FZ8MG.xx.xx.xx Summary of Firmware Releases

This document summarizes the following Z8MG.xx.xx.xx firmware releases

FZ8MG.04.04.00 General Release

FZ8MG.04.03.00 General Release

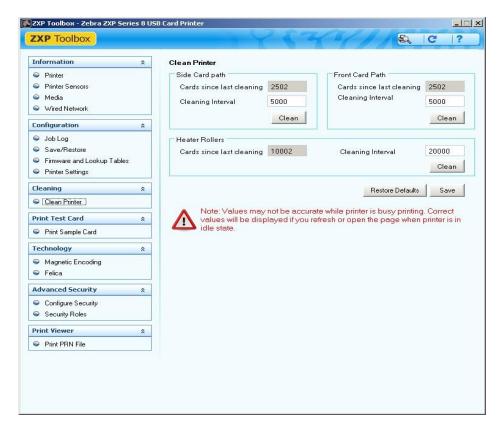
Due to the nature of certain firmware changes made in version 4.03.00, when upgrading the ZXP8 firmware from an older version of firmware, the user may notice a change in some values related to cleaning the printer. As reported in the Toolbox, the values for "Cards since last cleaning" will now be set to one-half of the "Cleaning Interval" value.

In the example below, the firmware was upgraded, the counts were reset to one-half of the cleaning intervals (2500, 2500, and 10000, for the Side Card Path, Front Card Path, and Heater Rollers, respectively), and two cards were printed, resulting in the values seen below.
